AE Wood IF- ADA Evaluation

IF-San Marcos TX, AE Wood ADA Evaluation

Accessibility Evaluation

Inspection Date: 12/05/2022

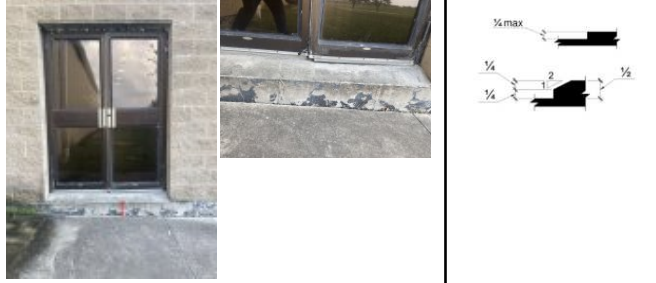
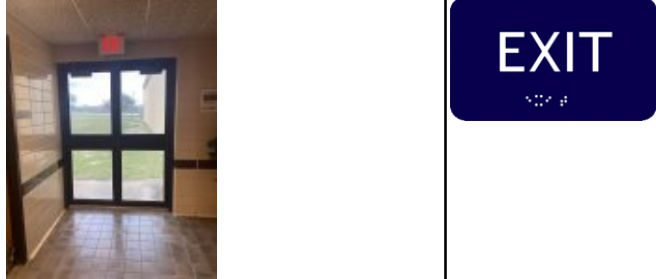
Finding Number	Area Description	Finding	As Built	Recommendation	Citation	Photos	Figure
4	Exterior of Property (Public) : AE Wood Parking Lot (1 Space) 1 Van - Pathway to Building (Van Accessible Stall to Main Entrance)	Significant sloping in curb ramp. The curb ramp exceeds the maximum running slope (parallel to the direction of travel) allowable of 8.33%.	N/A		https://www.access-board.gov/ada/#ada-406_1		
5	Exterior of Property (Public) : AE Wood Parking Lot (1 Space) 1 Van - Pathway to Building (Van Accessible Stall to Main Entrance)	The curb ramp side flares exceed maximum slope allowances. The sides of curb ramps (curb ramp flares) where provided, shall not be steeper than 1:10.	Located on (L) side of curb ramp.		https://www.access-board.gov/ada/#ada-406_3

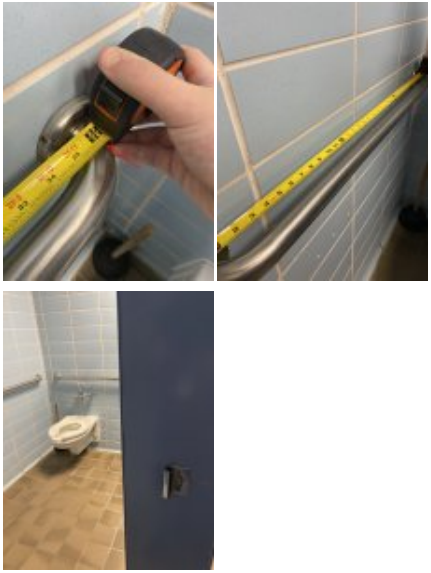
Finding Number	Area Description	Finding	As Built	Recommendation	Citation	Photos	Figure
6	Exterior of Property (Public) : AE Wood Parking Lot (1 Space) 1 Van - Pathway to Building (Van Accessible Stall to Main Entrance)	The route contains openings greater than 1/2 inch. Openings in floor or ground surfaces shall not allow passage of a sphere more than 1/2 inch diameter. Elongated openings shall be placed so that the long dimension is perpendicular to the dominant direction of travel.	on exterior pathway leading to front entrance.	https://www.access-board.gov/ada/#ada-302_3	2012 TAS Section: 302.3 2010 ADAS Section: 302.3 2015 ABAAS Section: 302.3		
7	Exterior of Property (Public) : Pathway to Holding Ponds - TOUR	The accessible route on the site has running slopes greater than 5 percent and has not been constructed as a ramp (i.e. handrails, edge protection, etc.). When the slope in the direction of travel of any walk exceeds 1 unit vertical in 20 units horizontal (5-percent slope), it must be constructed as a ramp. Surface cross slopes must not exceed one unit vertical in 48 units horizontal (2-percent slope).	Running slope near access point is not compliant. Exterior route meets majority of requirements for compliance and is considered accessible.	https://www.access-board.gov/ada/#ada-403_3	2012 TAS Section: 403.3 2010 ADAS Section: 403.3 2015 ABAAS Section: 403.3

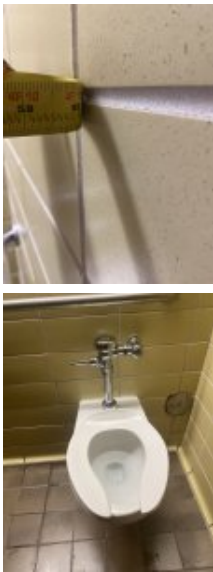
16	Structures on Property (Public) - Tour/Public Componets : AE Wood/Public Restrooms (Interior) - Restroom (Men's)	The force required to operate the element exceeds the maximum allowable force. The force required to activate operable parts is 5 pounds maximum.	Flush handle exceeds 5lbs force to operate.		https://www.access-board.gov/ada/#ada-309_4	2012 TAS Section: 309.4 2010 ADAS Section: 309.4 2015 ABAAS Section: 309.4

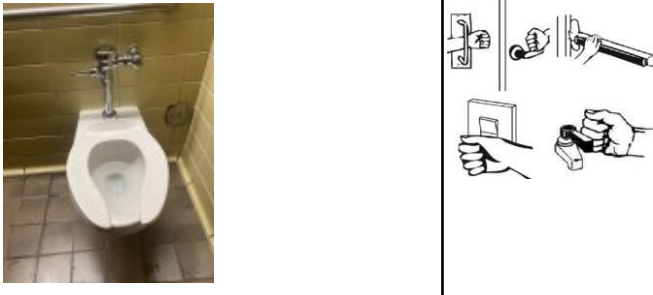
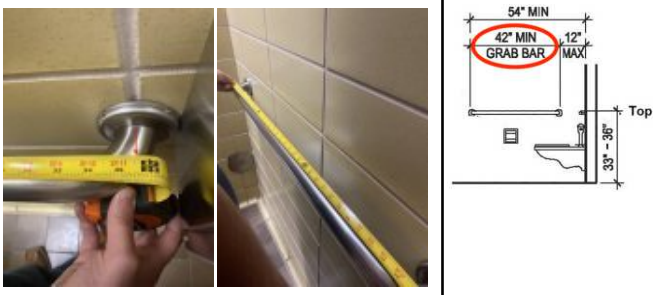
Finding Number	Area Description	Finding	As Built	Recommendation	Citation	Photos	Figure
19	Structures on Property (Public) - Tour/Public Components : AE Wood/Public Restrooms (Interior) - Restroom (Men's)	The locking/latching hardware is not accessible. Hand-activated door opening hardware, handles, pulls, latches, locks, and other operating devices on accessible doors shall have a shape that is easy to grasp with one hand and does not require tight grasping, tight pinching or twisting of the wrist to operate.	N/A	https://www.access-board.gov/ada/#ada-604_8_1_2	2012 TAS Section: 604.8.1.2 2010 ADAS Section: 604.8.1.2 2015 ABAAS Section: 604.8.1.2		
20	Structures on Property (Public) - Tour/Public Components : AE Wood/Public Restrooms (Interior) - Restroom (Men's)	The coat hook is installed greater than 48 inches above the finished floor. Where a forward reach is unobstructed, the high forward reach shall be 48 inches maximum above the finished floor.	Measures over 67"	https://www.access-board.gov/ada/#ada-308_2_1	2012 TAS Section: 308.2.1 2010 ADAS Section: 308.2.1 2015 ABAAS Section: 308.2.1

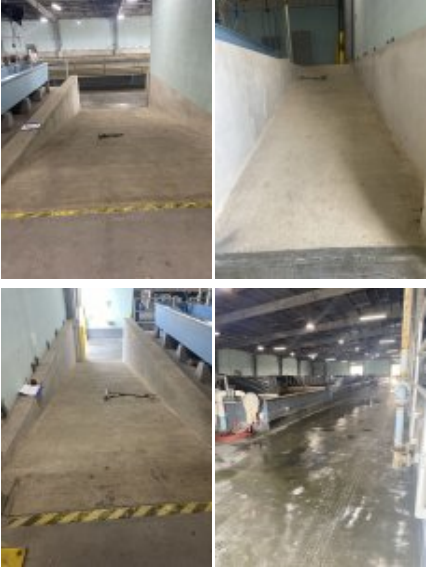
27	Structures on Property (Public) - Tour/Public Componets : AE Wood/Public Restrooms (Interior) - Restroom (Women's)	The force required to operate the element exceeds the maximum allowable force. The force required to activate operable parts is 5 pounds maximum.	Flush handle exceeds 5lbs force to operate.		https://www.access-board.gov/ada/#ada-309_4	2012 TAS Section: 309.4 2010 ADAS Section: 309.4 2015 ABAAS Section: 309.4	
28	Structures on Property (Public) - Tour/Public Componets : AE Wood/Public Restrooms (Interior) - Restroom (Women's)	The side grab bar is not long enough. The side grab bar must extend at least 54 inches minimum beyond the rear wall and start a maximum of 12 inches from the rear wall. A 42 inch grab bar installed the maximum distance from the rear wall (12 inches) will leave the leading end 54 inches from the rear wall. Grab bars shall be installed in a horizontal position, 33 inches minimum and 36 inches maximum above the finish floor measured to the top of the gripping surface.	Measures at less than 36"		https://www.access-board.gov/ada/#ada-604_5_1	2012 TAS Section: 604.5.1 2010 ADAS Section: 604.5.1 2015 ABAAS Section: 604.5.1

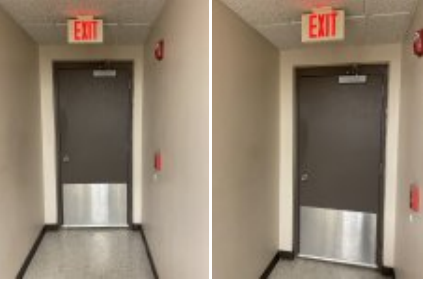
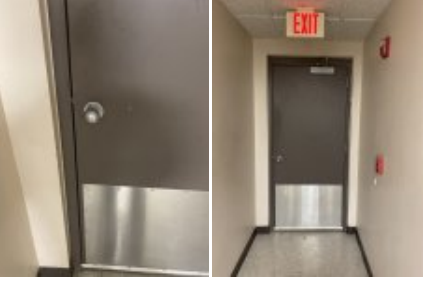
Finding Number	Area Description	Finding	As Built	Recommendation	Citation	Photos	Figure
40	Exterior of Property (STAFF) : TX River Studies Parking Lot (2 Spaces) 2 Van - Access Aisle (Van) Near Ramp	The cross slope (short dimension) of the access aisle exceeds 2%. The cross slope in an accessible parking stall and the access aisle must not exceed 2%.	Significant cross slope in access aisle, multiple locations are not compliant. See additional photos for details.	https://www.access-board.gov/ada/#ada-502_4	2012 TAS Section: 502.4 2010 ADAS Section: 502.4 2015 ABAAS Section: 502.4

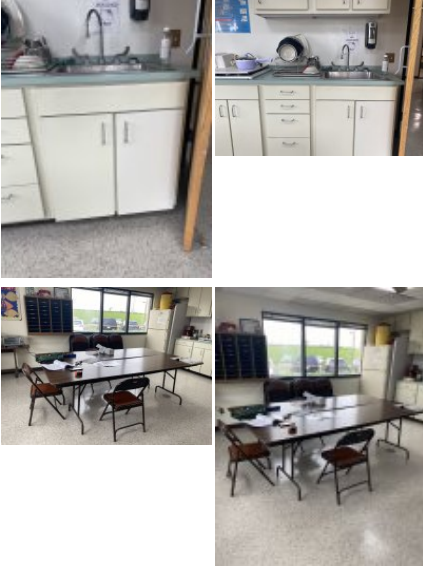
Finding Number	Area Description	Finding	As Built	Recommendation	Citation	Photos	Figure
44	Exterior of Property (STAFF) : Analytical Studies Parking Lot (1 Space) 1 Van - Van Accessible Stall	The cross slopes (narrow dimension) and/or running slopes (long dimension) of the accessible stall exceeds 2%. The running slope and the cross slope in an accessible parking stall and the access aisle must not exceed 2%.	Significant running and cross slope in van accessible stall, multiple locations are not compliant. See additional photos for details.	https://www.access-board.gov/ada/#ada-502_4	2012 TAS Section: 502.4 2010 ADAS Section: 502.4 2015 ABAAS Section: 502.4		
45	Exterior of Property (STAFF) : Analytical Studies Parking Lot (1 Space) 1 Van - Access Aisle (Van)	The access aisle is not a minimum 5 feet wide. An accessible parking stall's access aisle must be a minimum of 5 feet wide measured from centerline to centerline. Where the access aisle is not adjacent to another parking space or access aisle, measurements shall be permitted to include the full width of the line defining the access aisle.	Measures at 4'10"	https://www.access-board.gov/ada/#ada-502_3_1	2012 TAS Section: 502.3.1 2010 ADAS Section: 502.3.1 2015 ABAAS Section: 502.3.1

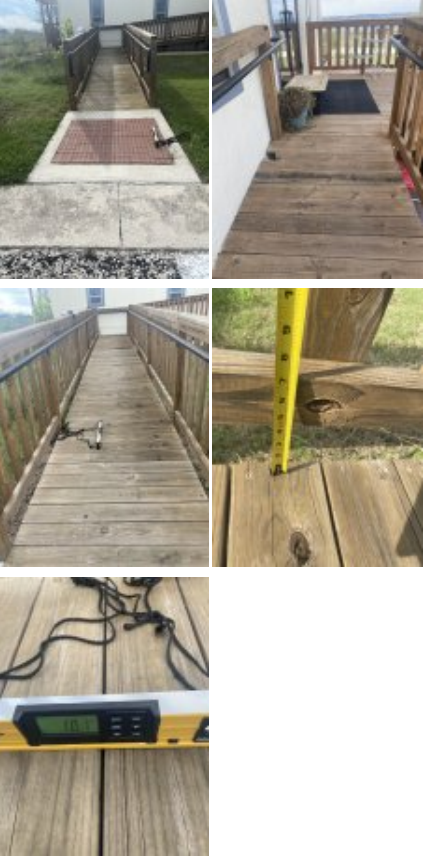
48	Structures on Property (STAFF) : AE Wood (Interior) - Entrance/Exit Doors	The door/gate operating hardware is not accessible. Hand-activated door/gate opening hardware, handles, pulls, latches, locks, and other operating devices on accessible doors shall have a shape that is easy to grasp with one hand and does not require tight grasping, pinching or twisting of the wrist to operate. Hardware shall be 34 inches minimum and 48 inches maximum above the finish floor or ground.	N/A	https://www.access-board.gov/ada/#ada-404_2_7	2012 TAS Section: 404.2.7 2010 ADAS Section: 404.2.7 2015 ABAAS Section: 404.2.7

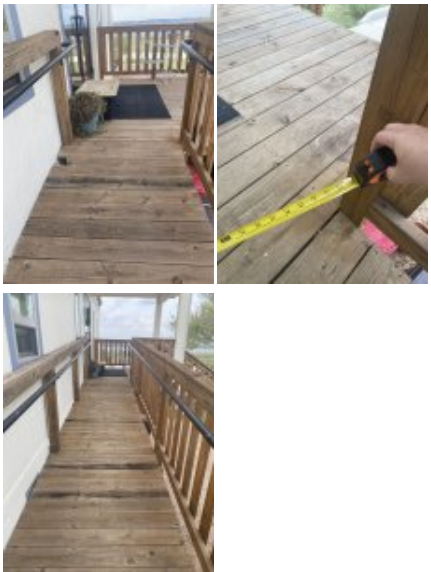
Finding Number	Area Description	Finding	As Built	Recommendation	Citation	Photos	Figure
51	Structures on Property (STAFF) : AE Wood (Interior) - Restroom/Showers (Men's)	An accessible urinal is not provided. Where more than one urinal is provided, at least one shall be accessible.	Urinals are not required in public bathrooms because building codes allow you to substitute them for toilets. It is also unnecessary to make a urinal accessible for people with disabilities if there is only one in the room. However, if there is more than one urinal in a bathroom, at least one must follow accessibility guidelines.	https://www.access-board.gov/ada/#ada-213_3_3	2010 ADAS Section: 213.3.3		
52	Structures on Property (STAFF) : AE Wood (Interior) - Restroom/Showers (Men's)	There are not enough accessible lavatories. Where lavatories are provided, at least one shall be accessible and shall not be located in a toilet compartment.	Restroom sinks are required to have front approach with knee and toe space provided. Mirror height and soap dispenser not compliant.	https://www.access-board.gov/ada/#ada-213_3_4 https://www.access-board.gov/ada/#ada-606	2012 TAS Section: 213.3.4 2010 ADAS Section: 213.3.4 2015 ABAAS Section: F213.3.4

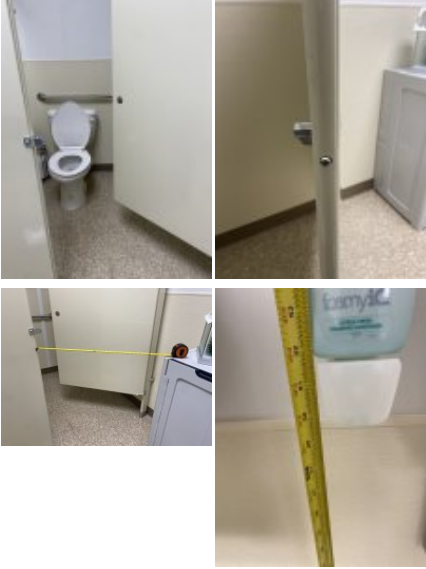
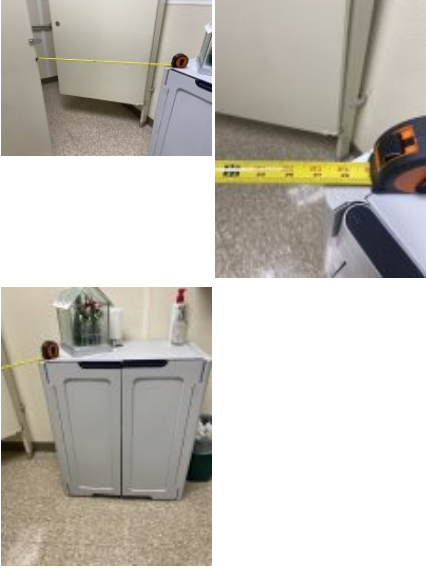
Finding Number	Area Description	Finding	As Built	Recommendation	Citation	Photos	Figure
57	Structures on Property (STAFF) : TX River Studies (Exterior) - Entrance Ramp (Non Curb Ramp)	The top landing of the ramp does not meet minimum size requirements. The landing clear width shall be at least as wide as the widest ramp run leading to the landing (36 inches minimum) and a minimum of 60 inches in length.	Obstructions prevent clear space requirements for top of landing.	https://www.access-board.gov/ada/#ada-405_7_2 https://www.access-board.gov/ada/#ada-405_7_3	2012 TAS Section: 405.7.3, 405.7.2 2010 ADAS Section: 405.7.3, 405.7.2 2015 ABAAS Section: 405.7.2, 405.7.3		
58	Structures on Property (STAFF) : TX River Studies (Exterior) - Entrance Ramp (Non Curb Ramp)	The landing at the bottom of the ramp has a slope greater than 2%. Bottom landings shall have a dimension in the direction of ramp run of not less than 60 inches and have a slope of 2% maximum in any direction.	Bottom of ramp landing slope exceeds 2% tolerance in any direction. Landing dimension meet compliance.	https://www.access-board.gov/ada/#ada-405_7 https://www.access-board.gov/ada/#ada-405_7_1	2012 TAS Section: 405.7.1, 405.7.1 Exception 2010 ADAS Section: 405.7.1, 405.7.1 Exception 2015 ABAAS Section: 405.7.1, 405.7.1 EXCEPTION

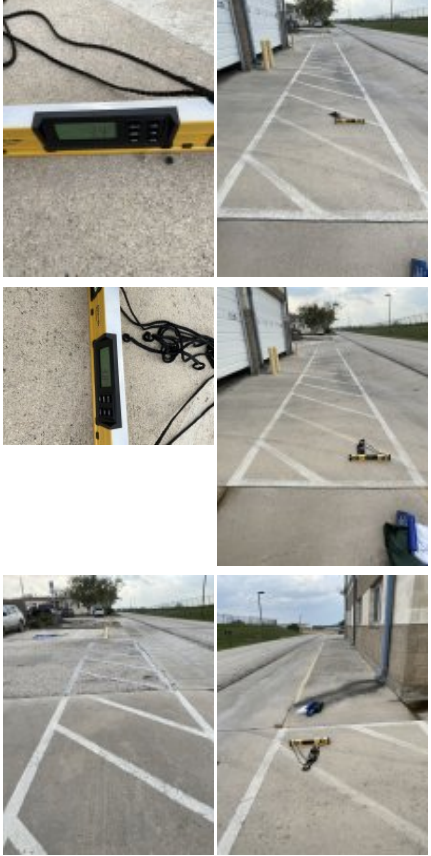
Finding Number	Area Description	Finding	As Built	Recommendation	Citation	Photos	Figure
59	Structures on Property (STAFF) : TX River Studies (Interior) - Entrance/Exit Doors	The door opening contains projections into the required door maneuvering clearances. Maneuvering clearances shall extend the full width of the doorway and the required latch side or hinge side clearance.	Obstruction prevents access to (L) side door.	https://www.access-board.gov/ada/#ada-404_2_4	2012 TAS Section: 404.2.4 2010 ADAS Section: 404.2.4 2015 ABAAS Section: 404.2.4		
60	Structures on Property (STAFF) : TX River Studies (Interior) - Entrance/Exit Doors	The maneuvering clearance at the door is obstructed. Maneuvering clearance for doors on the push side approached from the front must be flat (2% max. slope in any direction) and have a minimum length of 48 inches in the direction of travel.	(R) side door when exiting. Obstruction prevent access.	https://www.access-board.gov/ada/#ada-404_2_4_1	2012 TAS Section: 404.2.4.1 2010 ADAS Section: 404.2.4.1 2015 ABAAS Section: 404.2.4.1

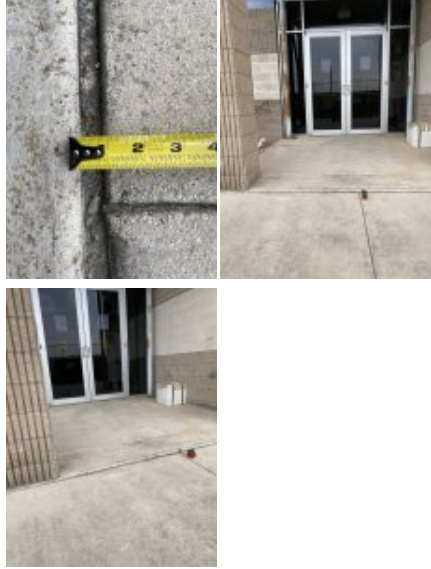
62	Structures on Property (STAFF) : TX River Studies (Interior) - Restroom (Men's)	The restroom has been found to be in substantial compliance with accessibility codes, standards, and regulations.	Restroom specs meet most requirements. Improve accessibility by moving storage space, adding handles on stall door, and lowering soap dispenser. Need photo verification of accessible stall.	N/A	2012 TAS Section: Advisory 2010 ADAS Section: Advisory 2015 ABAAS Section: Advisory

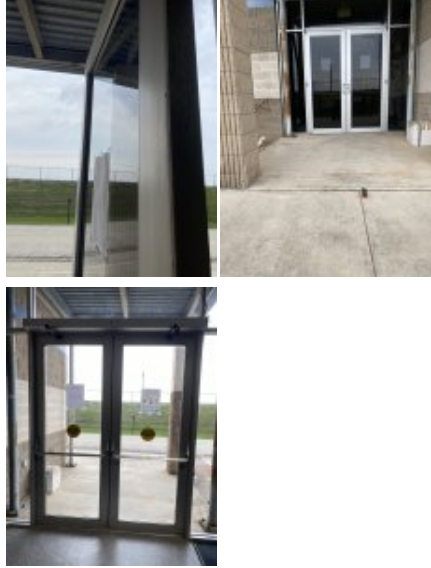
Finding Number	Area Description	Finding	As Built	Recommendation	Citation	Photos	Figure
63	Structures on Property (STAFF) : TX River Studies (Interior) - Restroom (Men's)	The route of travel does not provide a minimum width of 36 inches. The clear width shall be permitted to be reduced to 32 inches minimum for a length of 24 inches maximum provided that reduced width segments are separated by segments that are 48 inches long minimum and 36 inches wide minimum.	Access route narrowed by storage containers, passing space provided is not compliant, measured at 24" The clear width shall be permitted to be reduced to 32 inches (815 mm) minimum for a length of 24 inches (610 mm) maximum	https://www.access-board.gov/ada/#ada-403_5_1	2012 TAS Section: 403.5.1 2010 ADAS Section: 403.5.1 2015 ABAAS Section: 403.5.1	 	
64	Structures on Property (STAFF) : TX River Studies (Interior) - Restroom (Men's)	The soap dispenser's operation mechanism is too high off the floor. Dispensers must have all operable parts a maximum of 48 inches above the floor.	Soap dispenser out of reach range, measured at 50". Trash can placement prevents access	https://www.access-board.gov/ada/#ada-308_2_1 https://www.access-board.gov/ada/#ada-308_2_2	2012 TAS Section: 308.2.1 2010 ADAS Section: 308.2.1 2015 ABAAS Section: 308.2.1
